# BERMUDA INTEGRATED RESOURCE PLAN 2024

## STRATEGIC REVIEW

October 2024 | Rev G

Installed capacity of different generation and storage resources assumed in BELCo’s Integrated Resource Plan by 2050. © Charles Rivers Associates

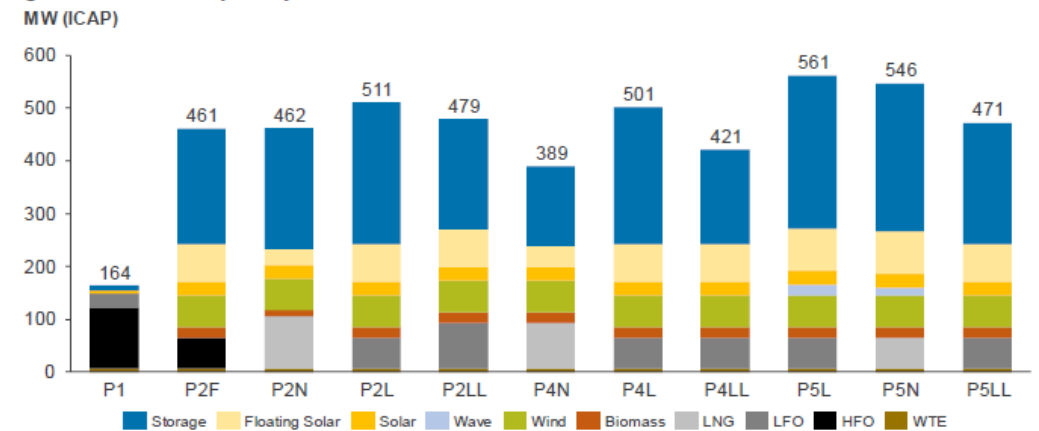
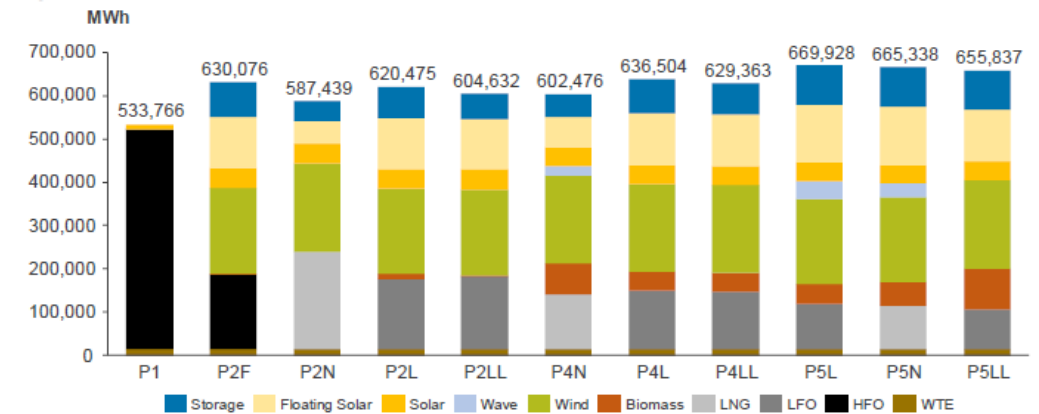
The adjacent graphs show the installed capacity and annual energy generated or stored, from different resources across the eleven portfolios by 2050. This does not include around 35MW of behind the meter solar. The portfolios can be split into four fuel strategies, outlined below, and these can be further subdivided into up to three strategies in terms of whether optimization was undertaken for ‘economics’ or emission reductions.

These portfolios both use **heavy fuel oil**, with P1 acting as a counterfactual portfolio, against which others can be compared. P2F is economically optimised via build-out of offshore wind, solar, storage, and biomass. These portfolios were not selected to take forward due to high emissions and fuel price volatility.

These portfolios all use **LNG** combined with a **30 year cycle** upgrade, with build-out of offshore wind, solar, storage and biomass. P2N is economically optimised, whereas P4N and P5N are designed to deliver 85% renewables by 2040 and as close as possible to net zero by 2050.

These portfolios all use **light fuel oil** with a **10 year life extension**, with build-out of offshore wind, solar, storage and biomass. P2L is economically optimised, whereas P4L and P5L are designed to deliver 85% renewables by 2040 and as close as possible to net zero by 2050. P4L was identified as BELCo’s preferred portfolio.

These portfolios all use **light fuel oil** with a **30 year life cycle upgrade**, with build-out of offshore wind, solar, storage and biomass. P2LL is economically optimised, whereas P4LL and P5LL are designed to deliver 85% renewables by 2040 and as close as possible to net zero by 2050. These portfolios were found to have increased costs relative to the shorter 10 year life extension option, and were therefore not preferred by BELCo.

Forecast reduction in residential energy demand due to energy efficiency. © Etude

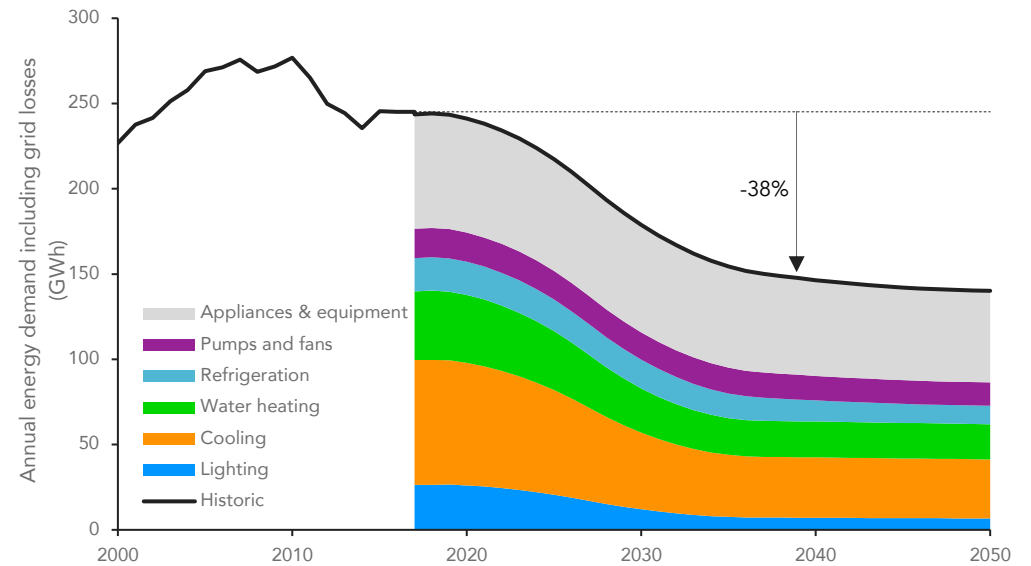
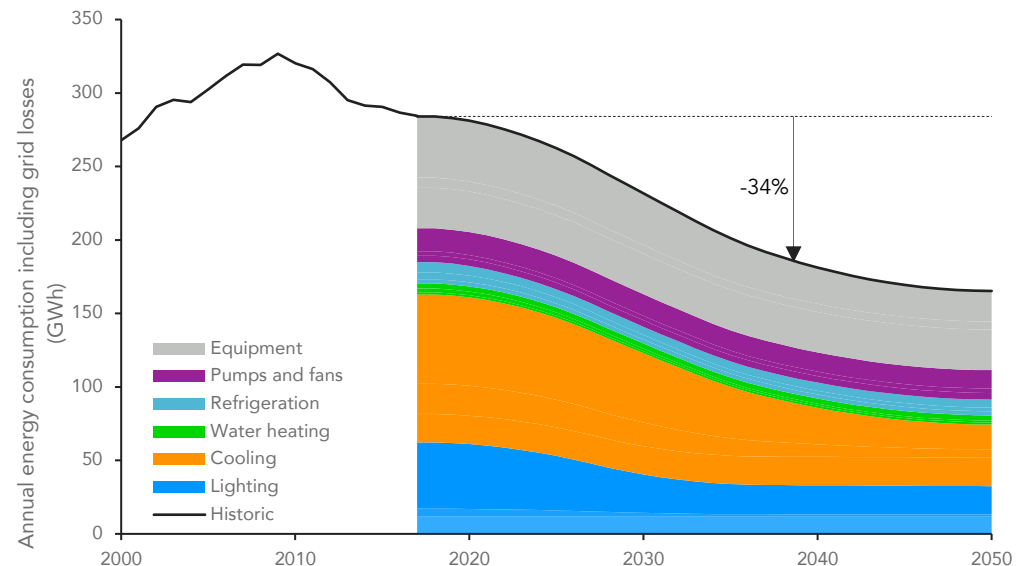
Allowance for reduction in energy demand due to energy efficiency in the IRP appears to be low at just 5.7%. For comparison, the 2018 Bermuda Better Energy Plan, which included detailed sectoral-level analysis, concluded that relative to levels in 2017, there was potential for a 32% reduction in net generation requirements by 2050. Comparison of Better Energy Plan forecasts with recorded energy sales by BELCo indicates they were reasonable, and in fact conservative. For example, the Better Energy Plan forecast net generation of 639GWh in 2022, the IRP reported just 585GWh.

Given that the IRP acknowledges that greater levels of energy efficiency will increase costs to customers for portfolios with LNG, we believe revision of the forecast potential for energy efficiency is necessary to provide a more realistic comparison between portfolios.

- Model at least one portfolio with a ~30% reduction in energy demand by 2050, due to energy efficiency.
- Consider establishing an energy efficiency taskforce to work with government to establish minimum efficiency product standards.

EV load shapes assumed in BELCo's Integrated Resource Plan, based on U.S. Department of Energy Alternative Fuel Data Centre model for Kahului. © Charles Rivers Associates

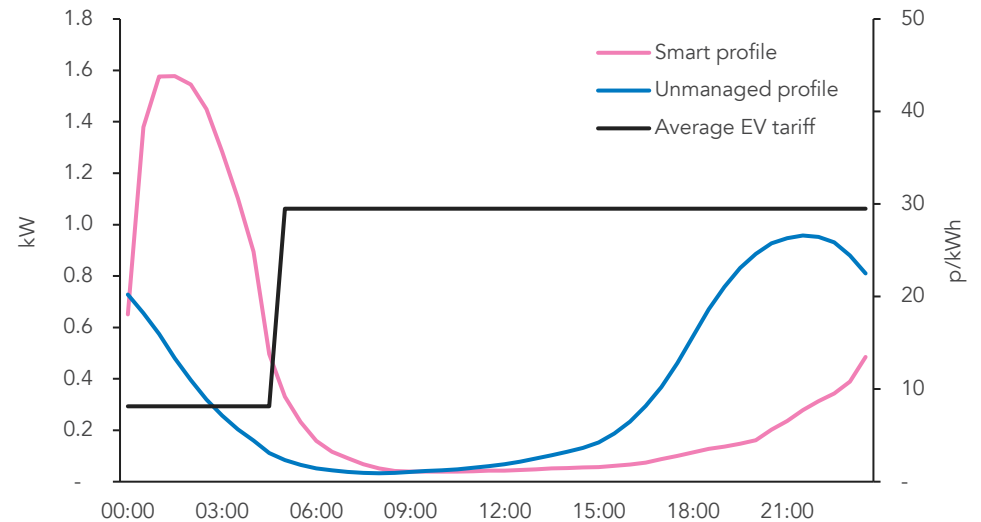
The upper adjacent graph shows the electric vehicle load profiles assumed in the IRP, while the lower graph shows the profiles assumed by the UK National Grid. The unmanaged (blue) profiles are similar in both magnitude of load and timing of load over a 24 hour period.

The smart profiles assumed in the National Grid modelling have been developed in conjunction with ev.energy, who we understand develop profiles based on models that combine their data on time of use pricing with charging behaviours. This produces realistic charging profiles for use in energy scenario planning.

- Model at least one portfolio with smart charging
- Model at least one portfolio with bidirectional charging
- Quantify potential reduction in cost from smart and bidirectional charging, and whether it would allow for cost-effective integration of more offshore wind and solar.

Levelised costs of energy calculated in the IRP Assessment Report were generally higher for renewables and lower for LNG than those calculated in BELCo's IRP and the Bermuda Better Energy Plan. A set of assumptions that is favourable to LNG appear to have been used. © Ricardo.

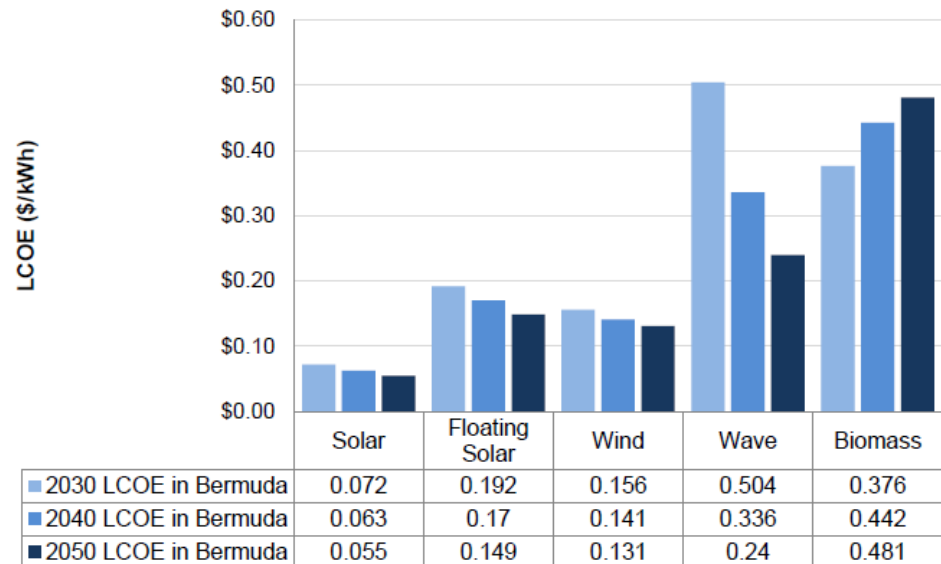
- The LCOE's indicated in the report are higher than those in BELCo's IRP. This appears to be due to the use of a 10% discount rate, which increases the cost for offshore wind and solar. No justification is provided for the higher discount rate. Reasons why we do not believe this is a sensible assumption include BELCo's cost of debt being around 8%, BVG Associates specifically recommending a 7.5% rate when calculating the LCOE for offshore wind in Bermuda, and local banks offering both mortgages and green loans for solar at 6.5% - 6.75%.

- We have low confidence in the LCOE figures calculated by the report as the assumptions used to calculate them are not provided. Spot checks indicate the figures for offshore wind appear to be high and use of a single figure for onshore solar may be overly simplistic given significant differences in cost between different types of system. LNG figures will depend heavily on infrastructure costs, which are not provided.

Weighting assigned to key performance indicators used in the IRP Assessment Report. © Ricardo.

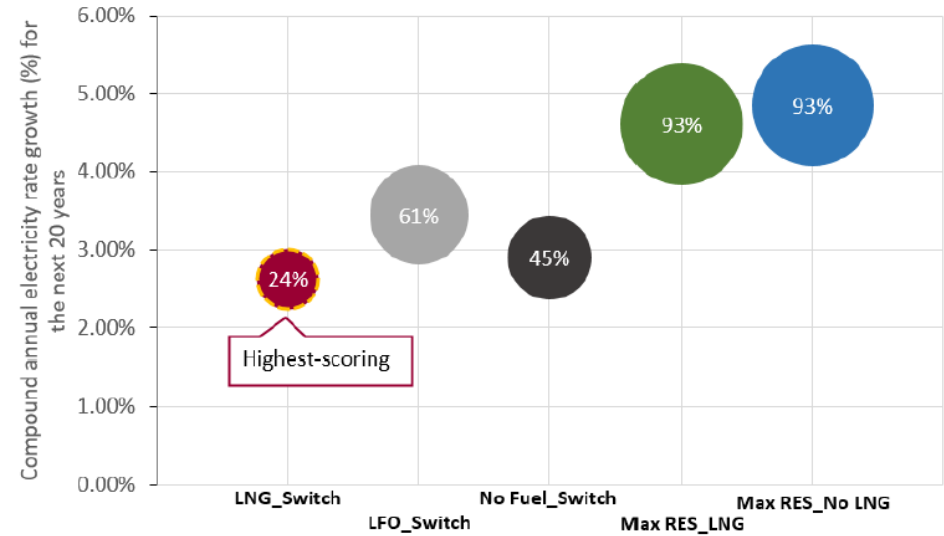
A general comment on the performance indicators is that the weighting is in our opinion arbitrary, and critically, does not appear to be aligned with the Electricity Act and National Fuel Sector Policy requirements to develop an environmentally sustainable energy supply. In our view a portfolio could only be considered to be 'environmentally sustainable' if it meets an IPCC 1.5°C decarbonisation pathway. More specific comments on the indicators are provided below:

- **Compound annual growth rate over 20 years** is a key indicator that we support being retained, with consideration given to whether it is an appropriate period given typical design lifetimes of 25-40 years for solar photovoltaic arrays, and 32 years for offshore wind turbines.

- **Carbon emissions** are assessed using scope 1 emissions. We regard this as a serious methodological issue for a strategic plan that seeks to deliver genuine emission reductions, given the significant out-of-scope emissions. We support use of lifecycle carbon emissions as the primary metric.

- **Renewable energy** indicators appear to be unnecessary given the carbon emissions indicator.
- **Dispatchable capacity** is of technical interest, but appears to be unnecessary assuming that all portfolios achieved the required 1 day in 10 year loss of load expectation. This is implied in the 0% weighting.

- **Resource diversity in 2050** may be of technical interest, but seems to be unnecessary. This is implied in the 0% weighting. It may also be overly simplistic as deploying an appropriate combination of complementary technologies seems to be more important than simply maximizing the number of technologies.

- **Operational risk** appears to be a sensible indicator, however we are unsure how it was calculated or why it was assigned a 0% weighting. A footnote implies it is, at least in part, due to a perceived need to operate engines under suboptimal conditions in conditions with greater amounts of intermittent renewable energy. However, this was not a risk identified by BELCo, who appear to have adopted technical solutions to mitigate this risk, such as using battery storage to control engine ramp rates.

Compound annual electricity growth rates calculated in the IRP Assessment Report using an undeclared set of assumptions. It is unclear if these are directly comparable with the values in BELCo's IRP © Ricardo.

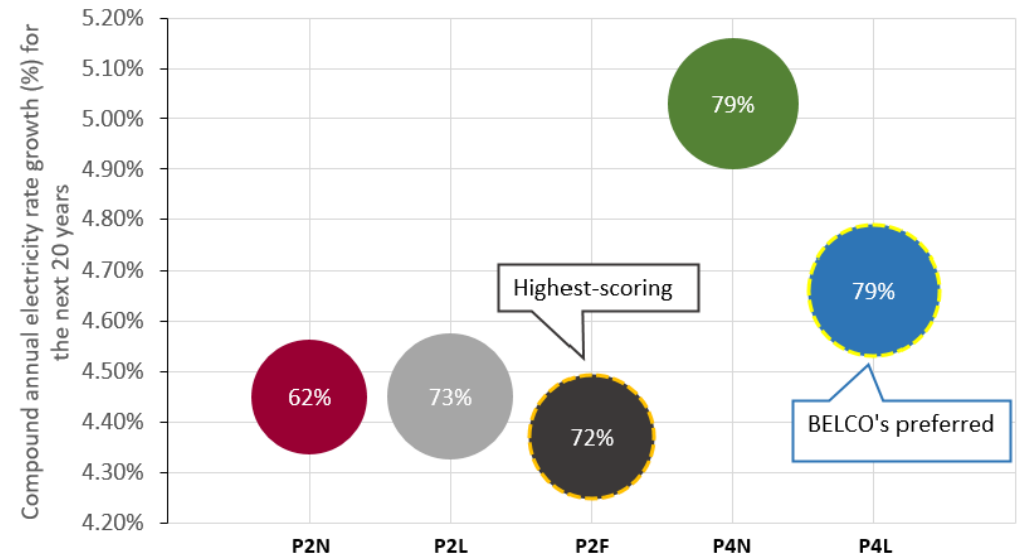
- We were unsurprised that the LNG\_Switch scenario was preferred based on the set of assumptions, indicators, and weightings used in the analysis. However, we do not consider this finding to be reliable and are confident that re-running the analysis with a more developed and realistic set of assumptions would identify lower cost portfolio options that retain light fuel oil while deploying large amounts of offshore wind, solar, and battery storage.

- The compound annual growth rate of 2.6% for the LNG\_Switch scenario is much lower than the value calculated in BELCo's IRP, however the reasons for this are unclear as the report claims similar LNG fuel price assumptions were used. This implies that capital costs for engine conversions and the regasification terminal may have been reduced. These are important assumptions that should be provided if the analysis is to be considered credible.

- A 31% reduction in emissions cannot occur in the LNG\_Switch scenario if lifecycle emissions are included. In any case, even a 31% reduction would not be compliant with an IPCC C1 1.5°C pathway, and could not therefore be considered 'environmentally sustainable' for the purposes of the Electricity Act or National Fuel Sector Policy.
